May 31, 2016

Re: FirstLight Hydro Generating Company, Turners Falls Hydroelectric Project (FERC No. 1889) and Northfield Mountain Pumped Storage Project (FERC No. 2485).
Response to Stakeholder Requests for Study Modifications and/or New Studies Based on the Study Report and Meeting Summary

Attachment A to Study 3.6.5
Revised Figure 4.4-1. Licensee Owned Lands

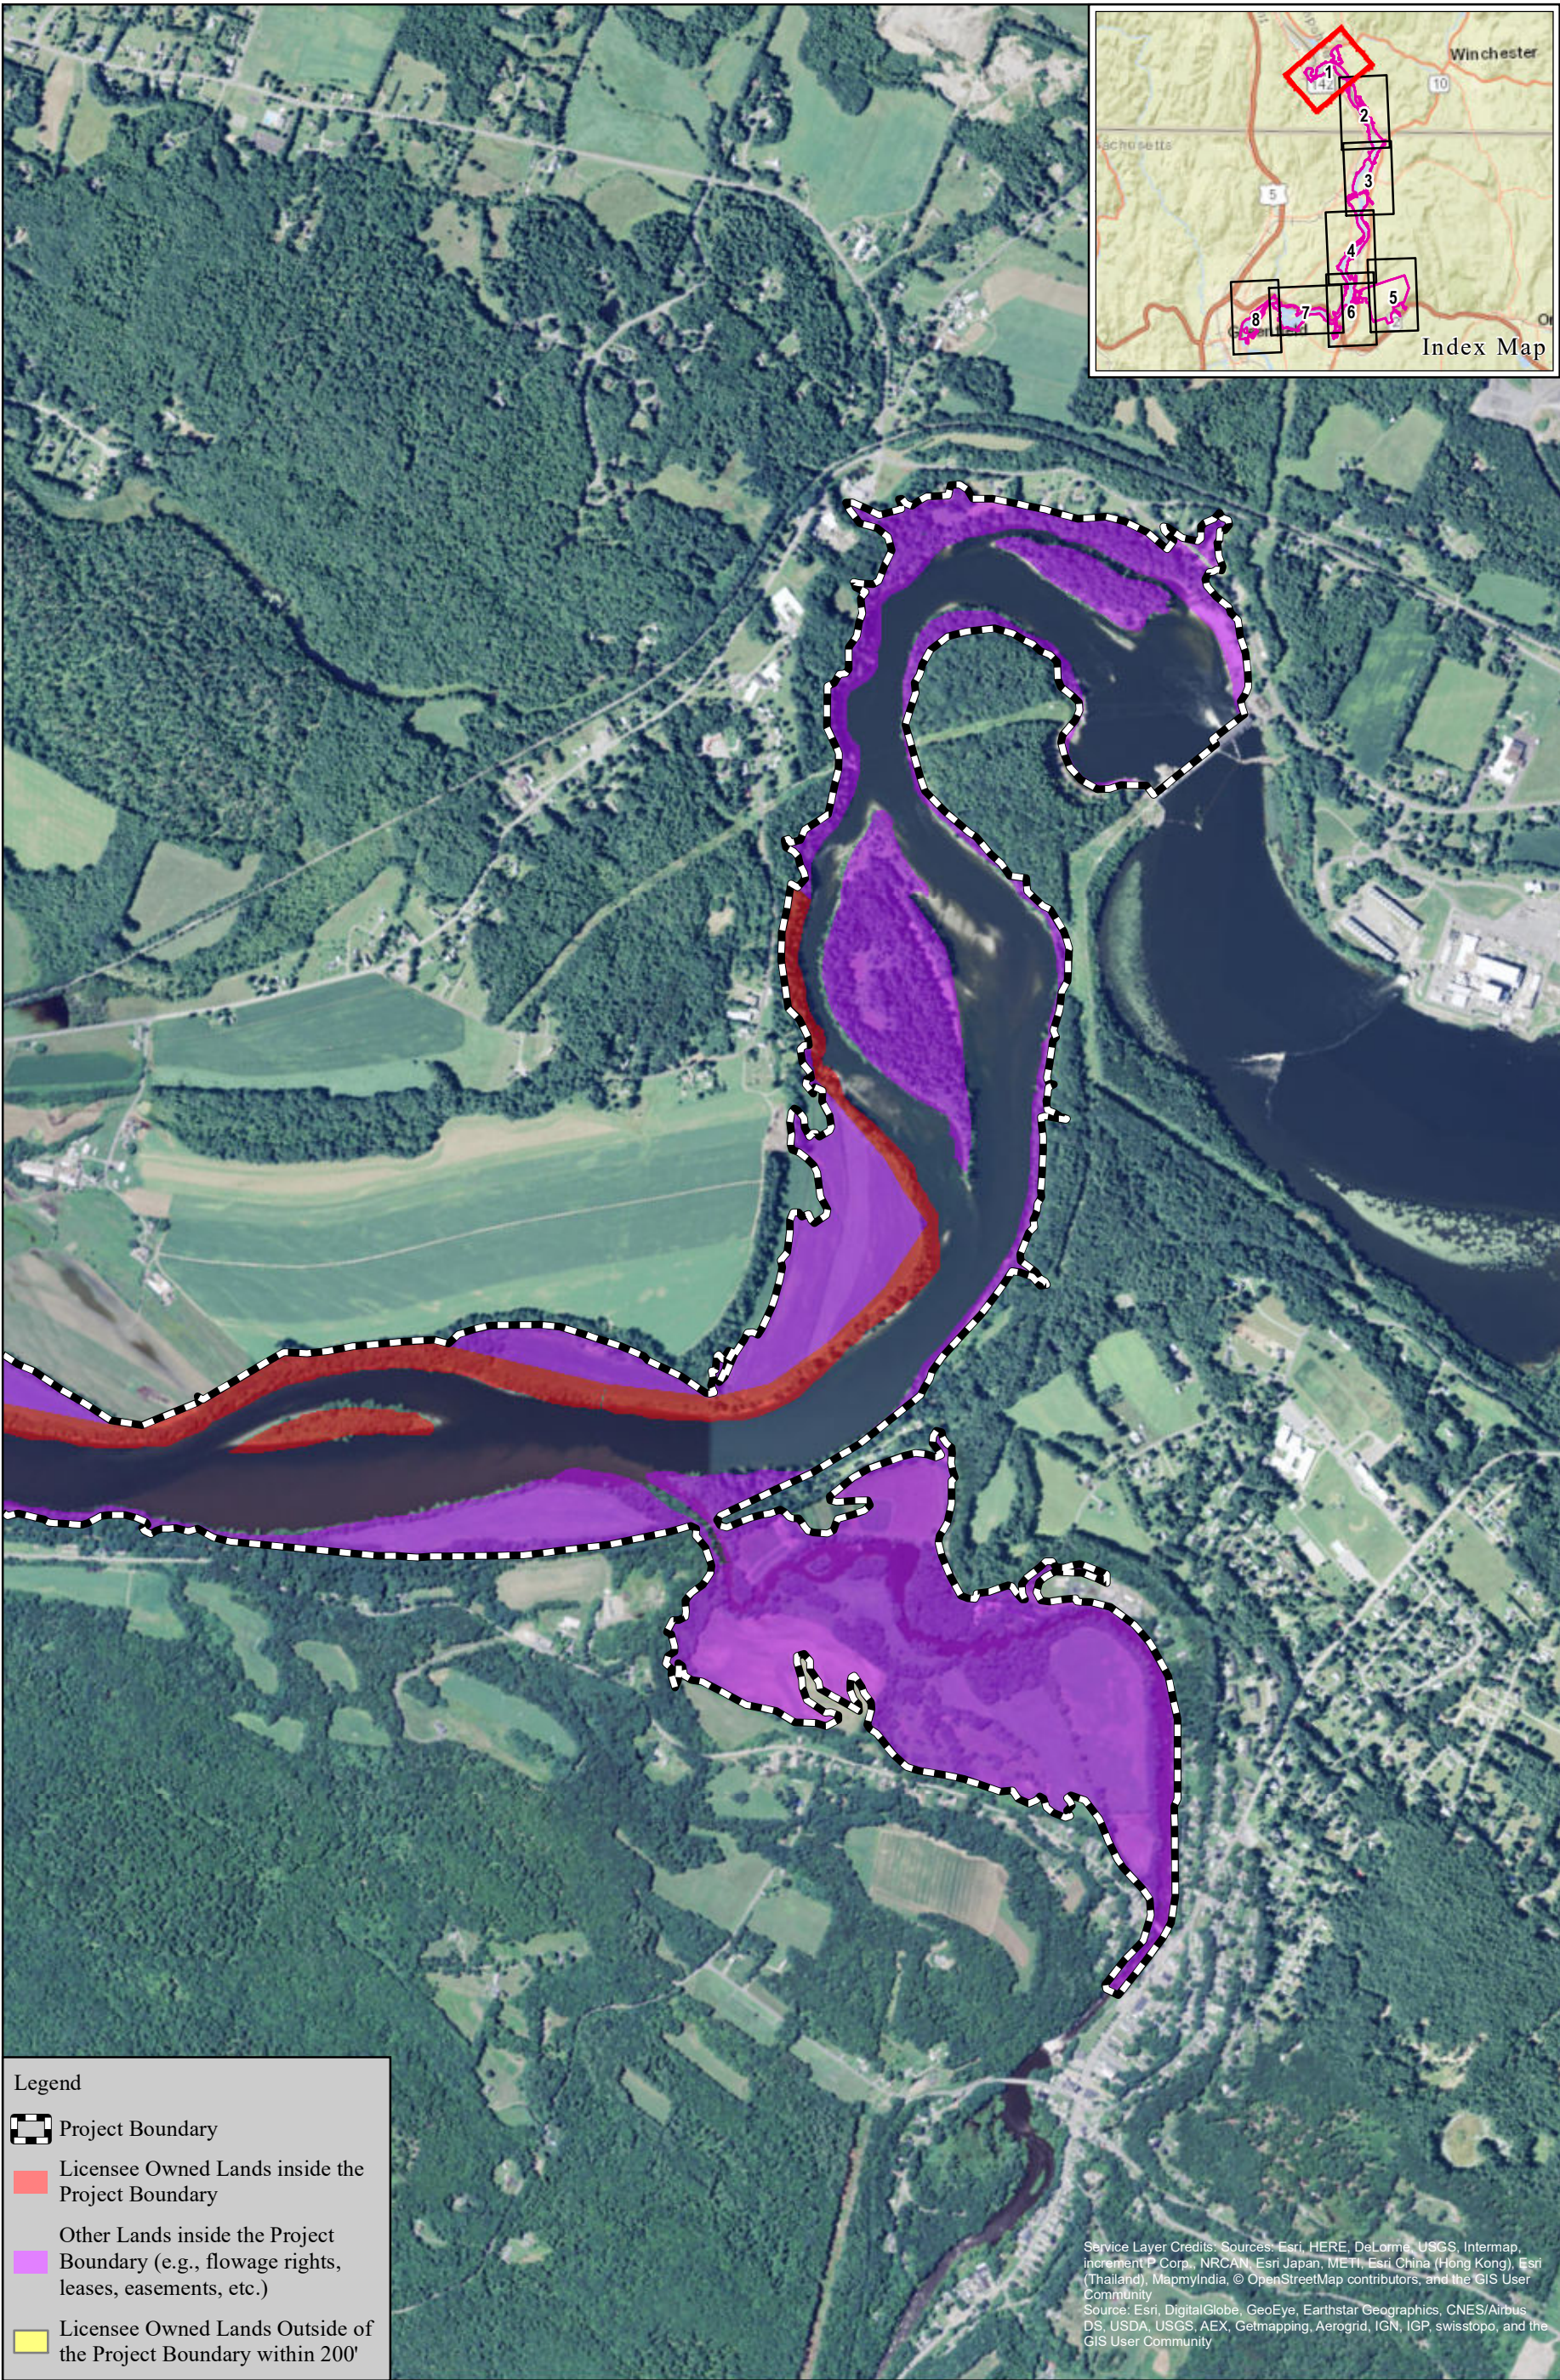
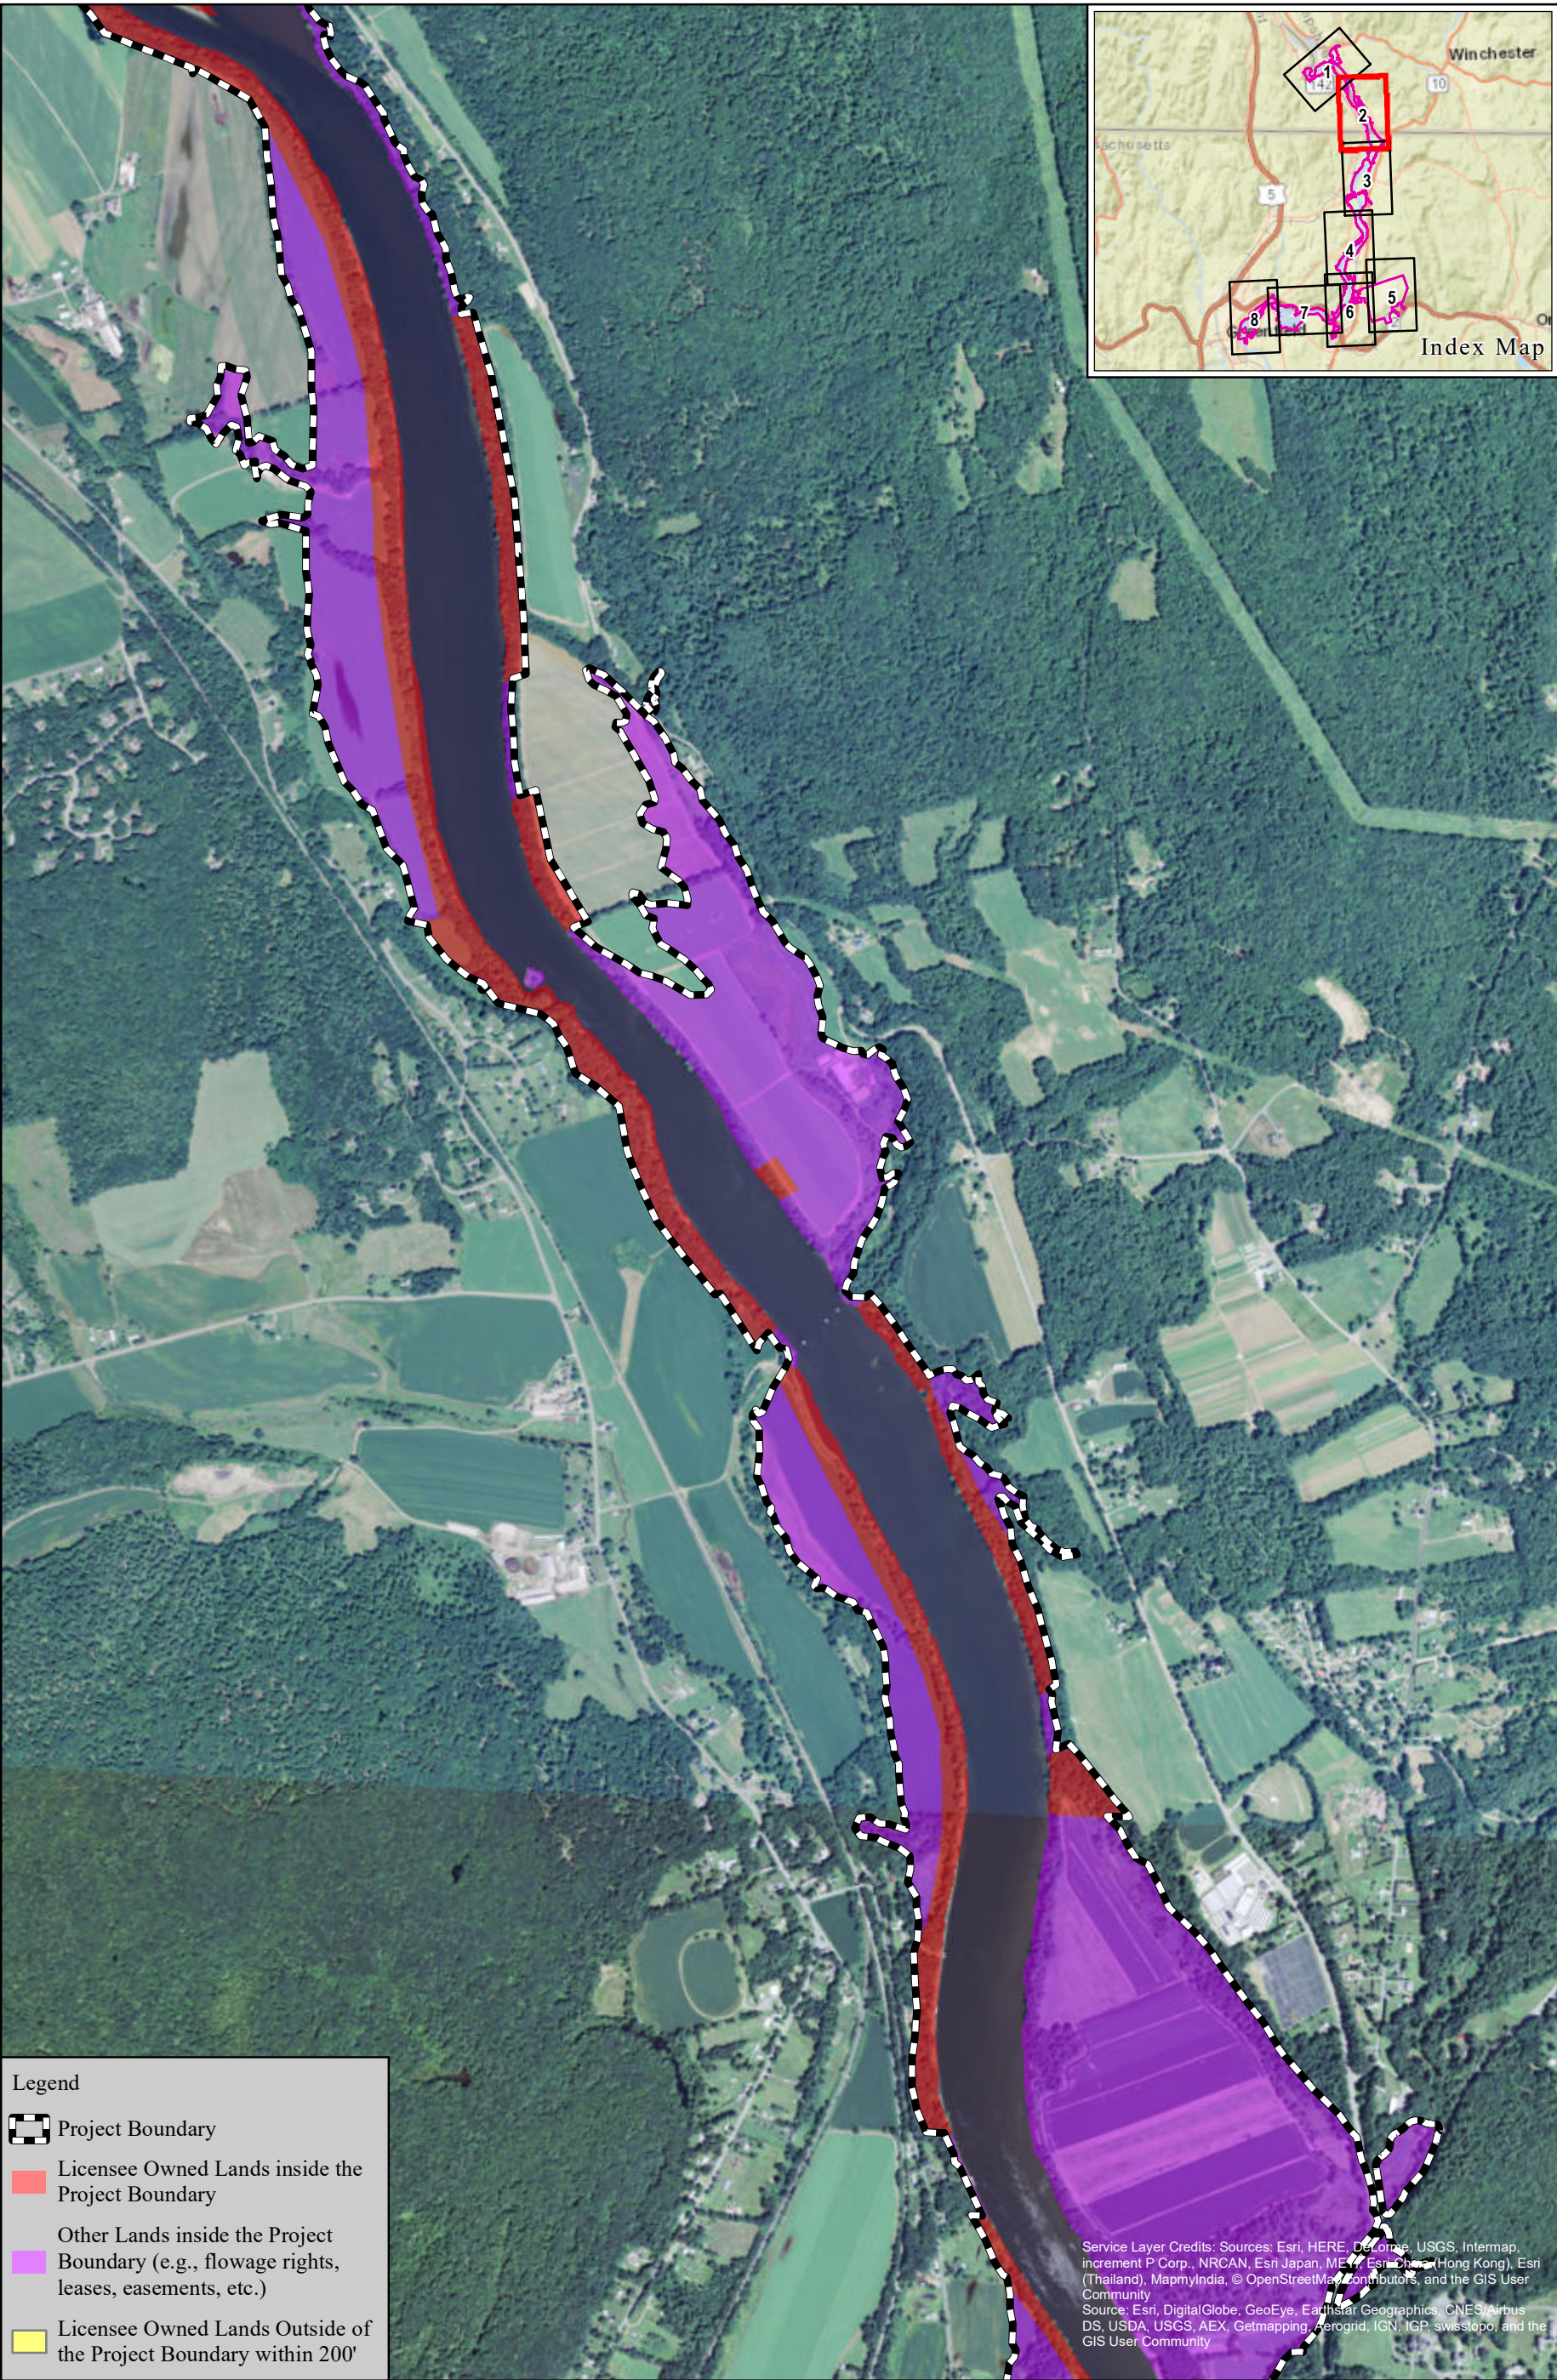
Commenter	Comment	Responses
CRWC-1	The report does not identify ownership and other controls such as FirstLight’s flowage rights within the Project boundaries. FirstLight does not own all of the lands within the project boundaries. FirstLight ownership of lands within 200 feet of the Project boundaries is identified in Figure 4.4-1, but nothing indicates ownership within the boundaries. CRWC requests that FirstLight provide information on land it has ownership or any other control over, and the land use associated with those lands, in an addendum to Study 3.6.5.	FL has updated the maps that comprise Figure 4.4-1 in the 3.6.5 study report to show FL land ownership within the project boundary. See Study 3.6.5 Attachment A , Figure 4.4-1. The lands owned by FL shown are fee-ownership. The figures also show other lands within the Project boundary (e.g., flowage rights, easements, leases, etc.). The land uses associated with all lands within the Project boundary are provided in the 3.6.5 study report. An addendum to the 3.6.5 study report is not necessary.
